PREVOST

Warranty Bulletin

95-20

Date: **July 1995**
 Section: **12**
 Subject: **Pressure Relief Valve on the Rockwell Wabco System Saver 1000 Air Dryer**

FIGURE 1: SYSTEM SAVER 1000 AIR DRYER AND PRESSURE RELIEF VALVE

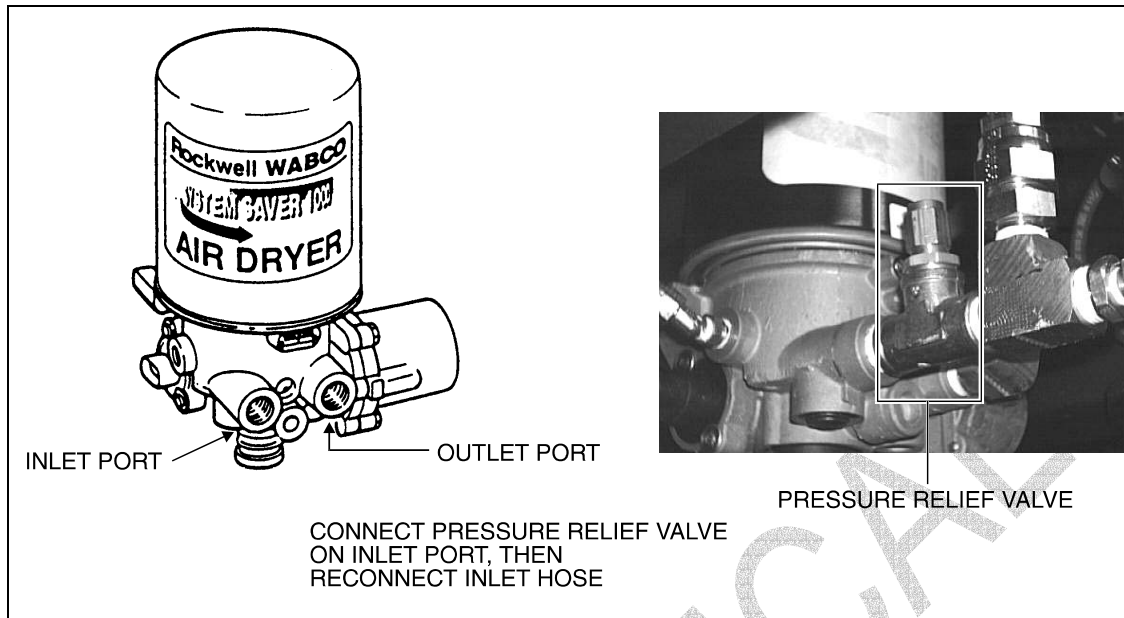
Rockwell Wabco has recently detected that, in certain conditions, the *System Saver 1000* air dryer may become overpressurized. If the air dryer becomes overpressurized, the air dryer cartridge may separate from the mounting base. If the air dryer cartridge were to separate from the mounting base, the separated cartridge may cause personal injury or property damage. In order to remedy this defect, Rockwell Wabco proposes to install a pressure relief valve to the inlet port of the air dryer. You must do this modification according to the following instructions.

1. Exhaust air from the air system by opening the valve under wet tank. On H3 Series vehicles: wet tank is located in front of rear wheels section; on XL Series vehicles: wet tank is located over drive axle on L.H. side of vehicle.
2. Locate air dryer in front of rear axles section. Disconnect hose(s) and fitting from inlet port of air dryer (Fig. 1) (it could be necessary to disconnect other hoses and fittings to disconnect inlet hose).

Warning: Pressure relief valve should be installed in the up position (Fig. 1) or within 30° of vertical position.

3. Apply *Loctite* 567 type thread sealant (Prévost #680098) on male threads of pressure relief valve (Prévost #641350), then connect it directly on air dryer's inlet port, do not exceed torque of 35 lbf•ft (47 N•m). Apply thread sealant on male threads of hose(s) and fittings disconnected in step 2, then reconnect them.
